# Axminster Respiration Monitor

Service Update 010608

SERIAL NUMBERS 001360 to 001660

Monitor Model AE 010 M

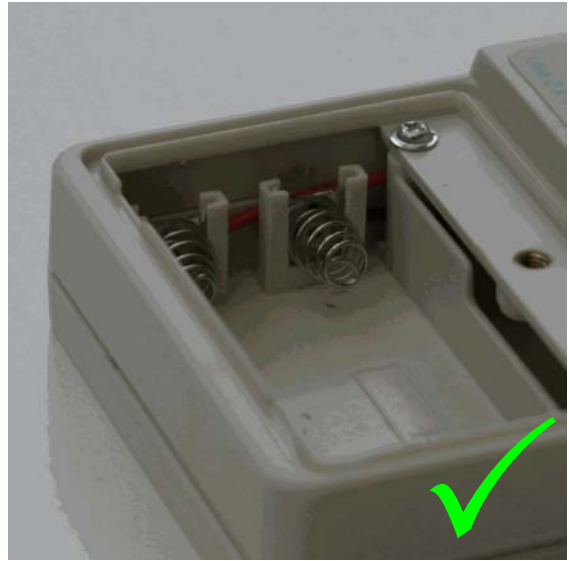
**It has been brought to our attention that if the monitor is subjected to physical impact the battery terminals can become loose. We recommend that the condition of the battery terminals be regularly inspected.**

**The problem has since been prevented with a spring coil battery terminal on monitors serial number 001660 to 001950 and by using our original battery terminal from 001951 to date. We recommend that if the monitor has a serial number between 001360 and 001660 and is not fitted with coil spring battery terminals that they are returned for upgrading. Serial numbers below 001360 use a flat spring made from a more resilient material which we have not experienced problems with, this has been used again from serial number 001951 to date.**

Replace terminals of this type.

Coil Spring terminal fitted.

If your monitor(s) have serial number(s) between 001360 and 001660 and are not already fitted with coil spring battery terminals you may return the monitor(s) for upgrade. Please return to: -
